Re: Development Application SSD 8373 – Alexandria Park Community School Redevelopment, Park Road, Alexandria 2015

Fig 1

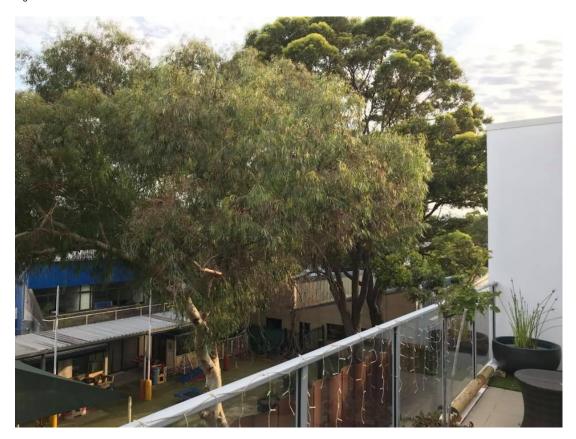
Fig 1 & Fig 2 are photographs of the current view from my balcony which is level 3, being the top level of 141-143 McEvoy Street. As you can see having the trees and the current buildings set back most certainly improves the visual aspect and living standard in our urban setting.
